Technical Service Bulletin

NUMBER: 18-20-99

Harsh A/C Initial Engagement – Clunk Noise

2000 (PL) Neon

FIGURE 1

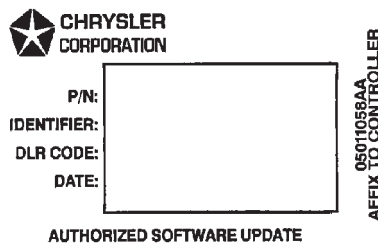
4. Type the necessary information on the “Authorized Software Update Label” p/n 05011058AA (Figure 1). Attach the label to the PCM and cover the label with the clear plastic overlay.
